Temperature Screening Thermographic Camera Version:V5.5.26 build200708

Release Note

Firmware Version	V5.5.26 build 200708

Web page prompts face capture attribute

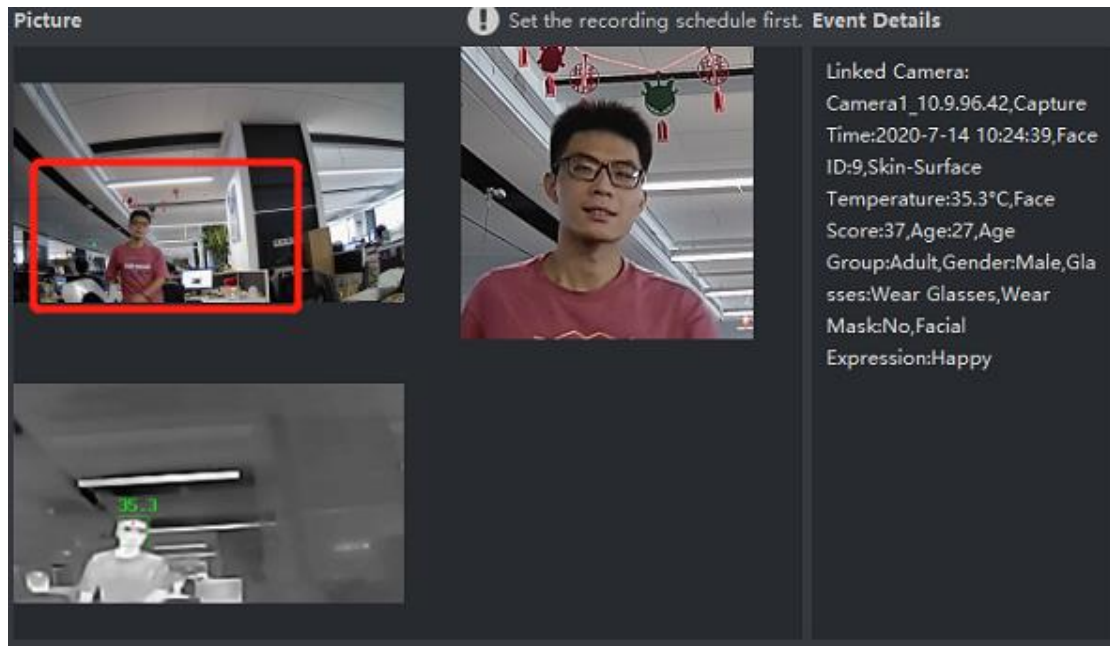
1. Added prompt for face capture attributes on web page (age, gender, whether to wear a mask, glasses, facial expression information)

Stream information switch

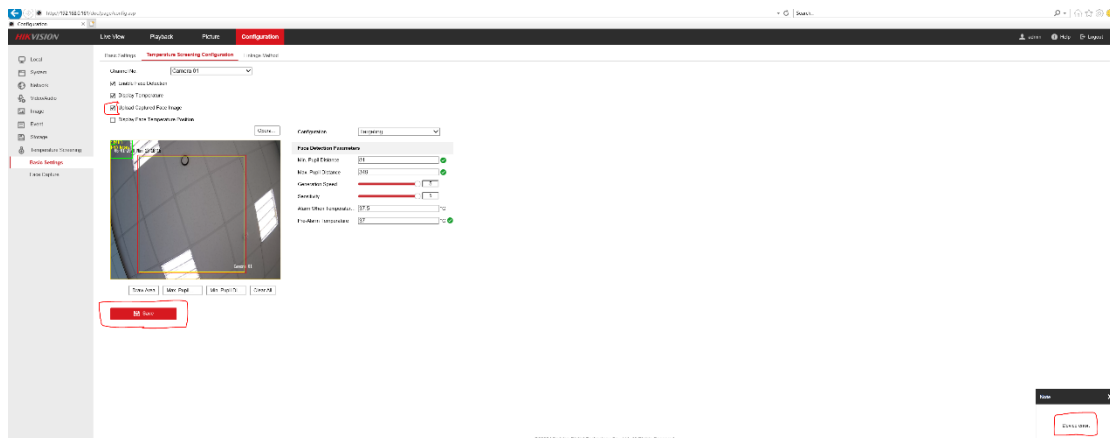
1. Fix the issues that the temperature information and face frame are not displayed when restarting the device, after turning off the function of displaying temperature information in the stream information of the human body temperature measurement mode.
